Subject: Submittal of the NAC International Responses to the Conference Call Request for CY-STC SAR Clarifications

Docket No. 71-9235

**REQUEST FOR SAR CLARIFICATIONS**

**NAC STORAGE TRANSPORT CASK (NAC-STC)**  
**CONNECTICUT YANKEE AMENDMENT**

Figure 26-1 Finite Element Model for Strain-Rate Dependent Crushable Foam/Wood Block Impact

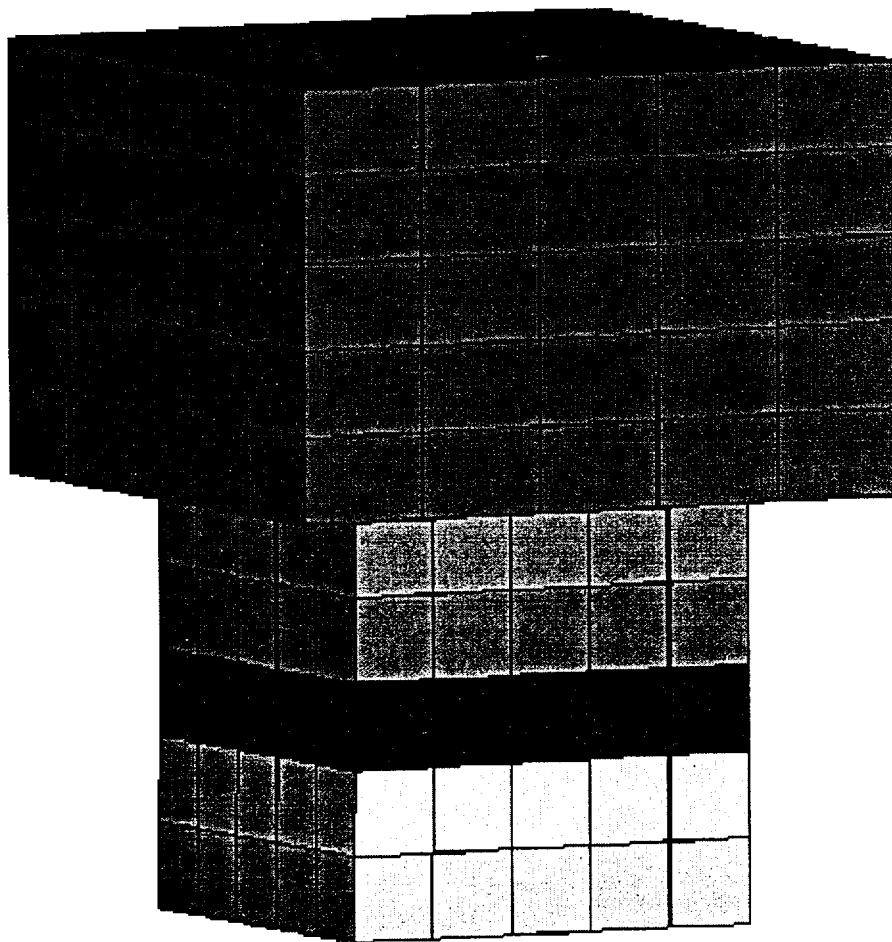
NAC Response

Strain rate sensitive materials are used for all 1/4-scale and full-scale LS-DYNA analyses. Section 2.10.3 has been revised to clarify the LS-DYNA computer code description and the following benchmark case has been added in that section. This case shows that strain rate dependent material models properly interpolate between stress-strain curves at a given strain rate.

The strain rate sensitive foam/wood is modeled using the LS-DYNA finite element model builder. The model is comprised of a steel block and a wooden cube. The model, Figure 26-1, is constructed of solid brick elements. The wooden cube measures 5 inches by 5 inches. The impacting steel plate is 5 inches tall and 7.5 inches across. Surface to surface contact interfaces are employed between the steel block and the wooden cube. The wooden cube sits on a rigid plane.

The Piecewise\_Linear\_Plasticity material model is used to represent the steel block. The wooden cube is represented as a homogeneous isotropic material, type number 163 in LS-DYNA (Modified\_Crushable\_Foam). For this example, three strain-rates are defined in the material model, 0  $\epsilon$ /sec, 20  $\epsilon$ /sec, 40  $\epsilon$ /sec with corresponding stress values of 2,000 psi, 7,000 psi, and 10,000 psi, respectively. A prescribed motion is applied to the steel block to model a constant strain rate to the wood cube. For a strain rate of 20  $\epsilon$ /sec, a prescribed motion equivalent to a velocity of 31 in/sec is applied to the

To demonstrate that the correct strain rate curve is used during the crushing of the wood cube for the two cases considered, the stress in the wood block should compare to the applied stress-strain curve at the strain rate of interest. For the 20  $\epsilon$ /sec case, the compressive stress in the cube is approximately 7,000 psi. For the 40  $\epsilon$ /sec case, the compressive stress in the cube is a value between 7,000 and 10,000 psi. Figures 26-2 and 26-3 show the stress plot for each case at an element located at the geometric center of the cube. As the figures show, LS-DYNA used the proper stress-strain curve for the applied strain rate. Therefore, the modified\_crushable\_foam material model is an acceptable method of accounting for the strain-rate variability of foam and wood crushable materials.
